PSL - Frequency Stabilization

80 MHz VCO Rev. B01

Engineering Change Order History		
ECO number	Date	Originator
1	E010167	BK
2	E020102	BK
3		
4		
5

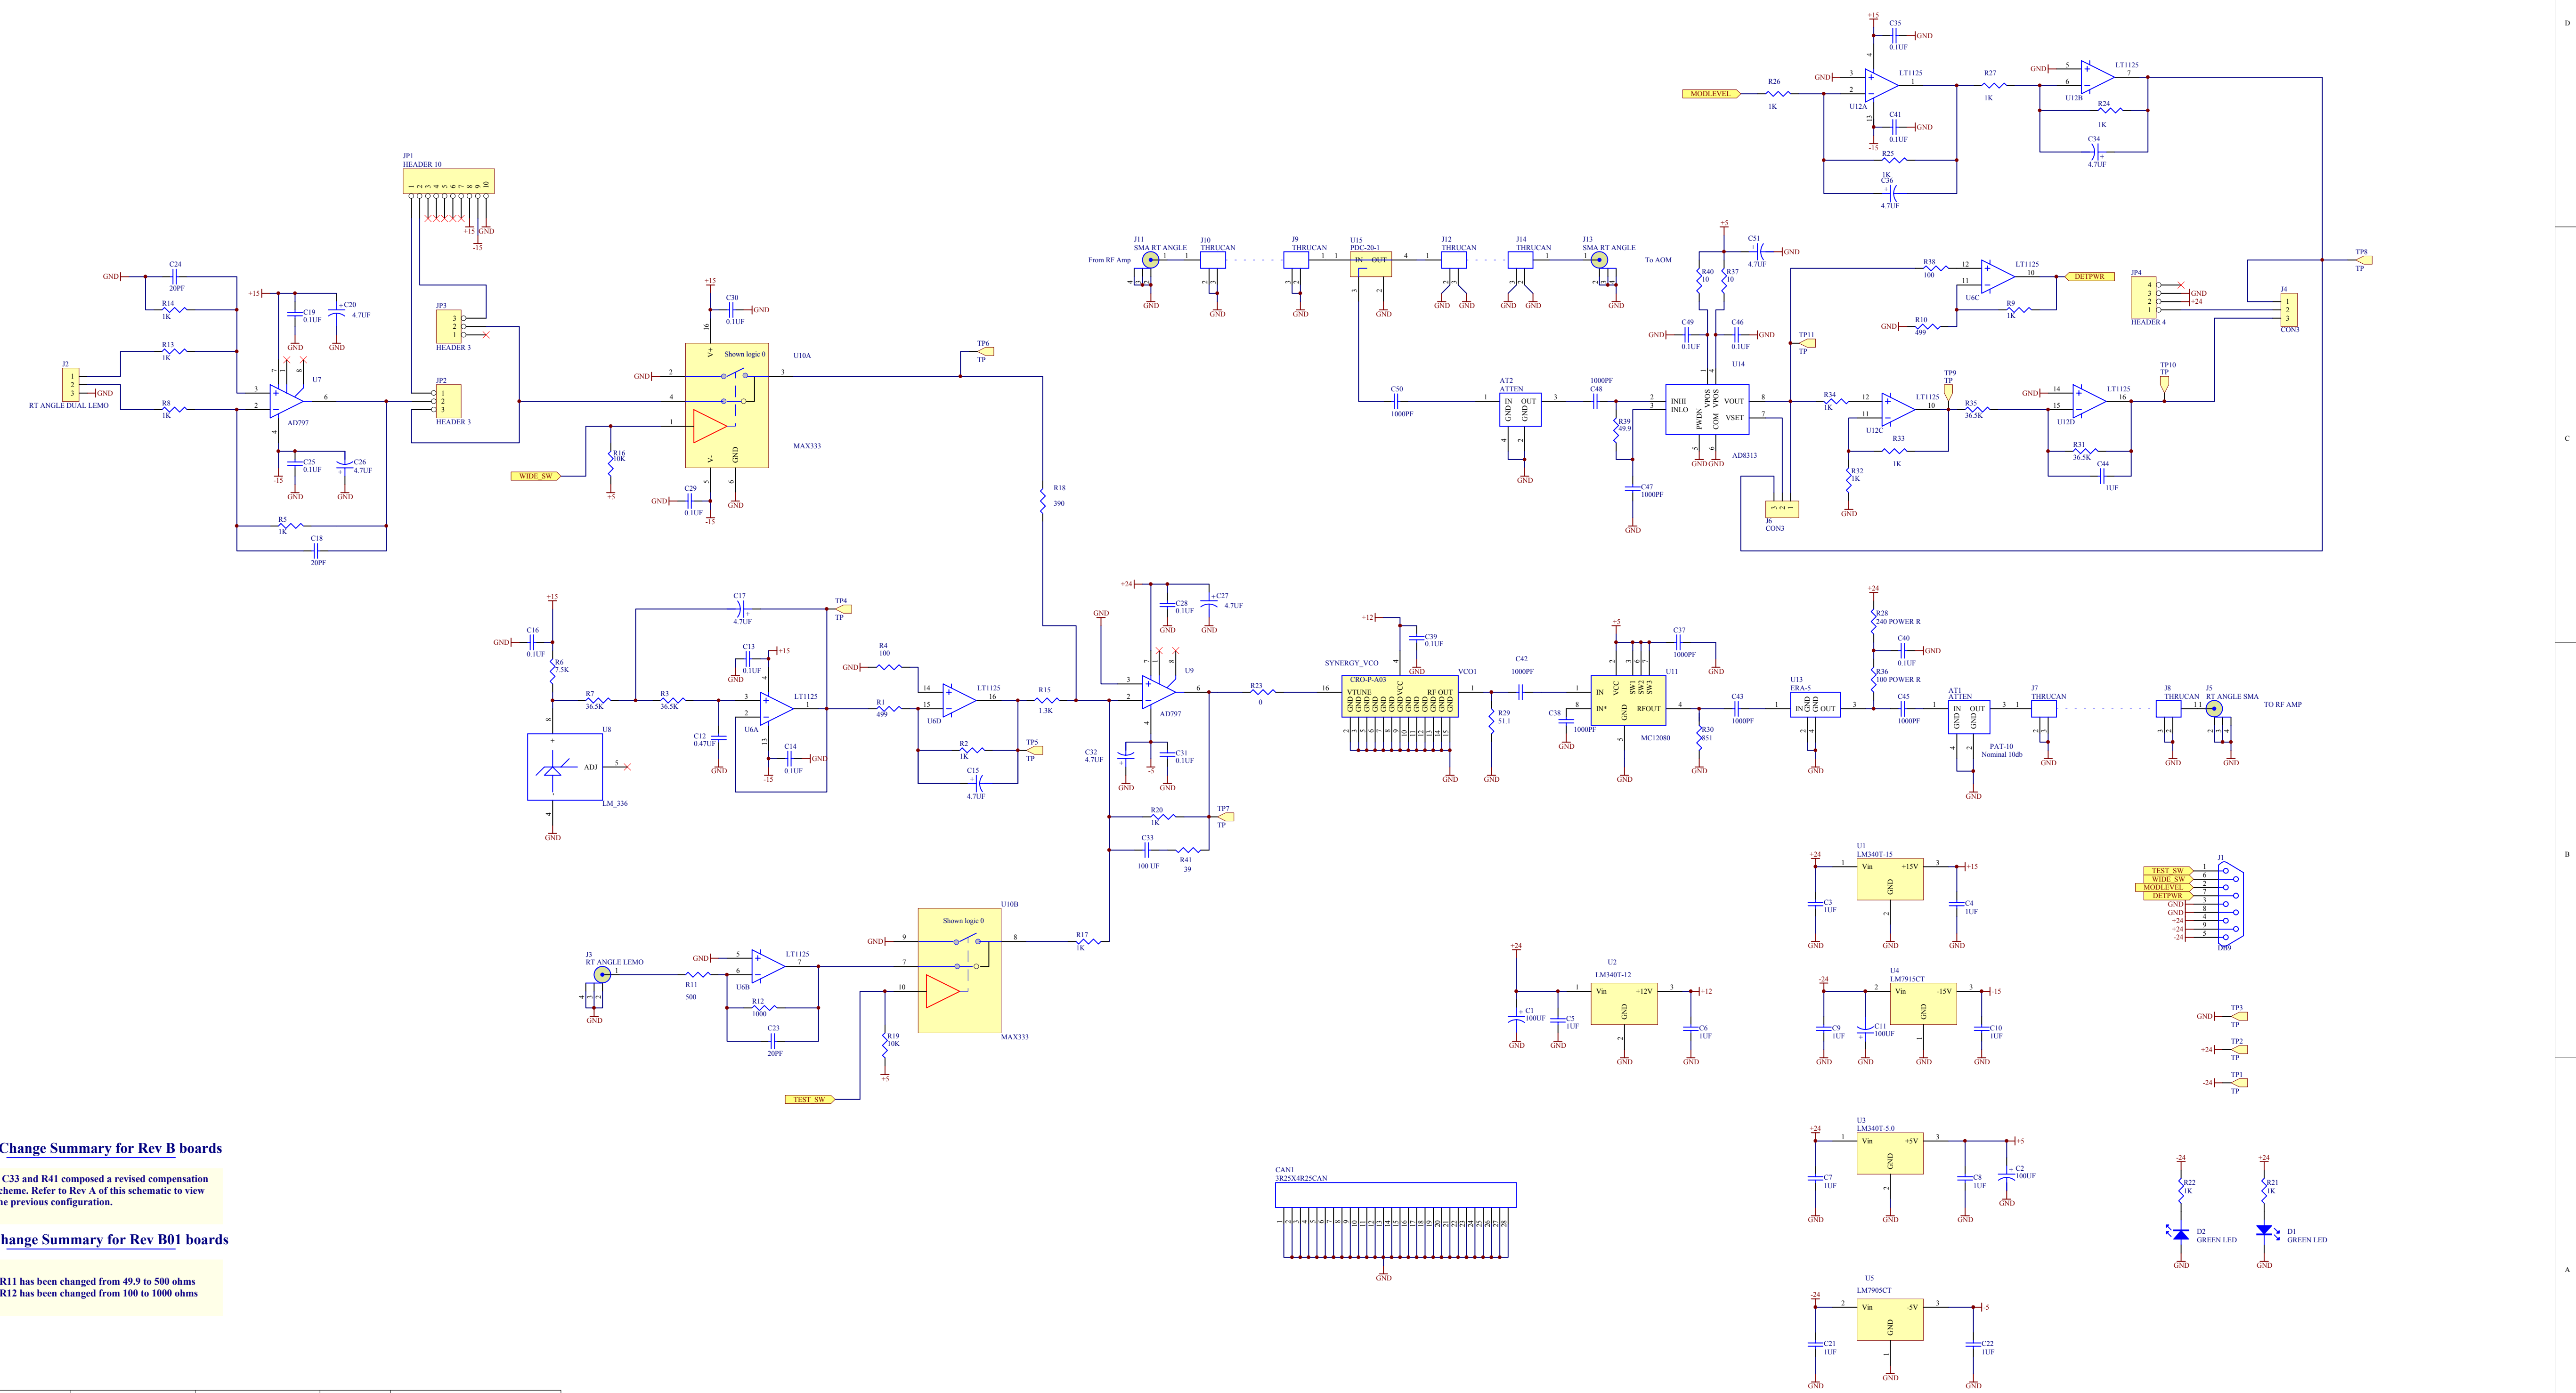
- * C33 and R41 composed a revised compensation scheme. Refer to Rev A of this schematic to view the previous configuration.

- * R11 has been changed from 49.9 to 500 ohms
- * R12 has been changed from 100 to 1000 ohms
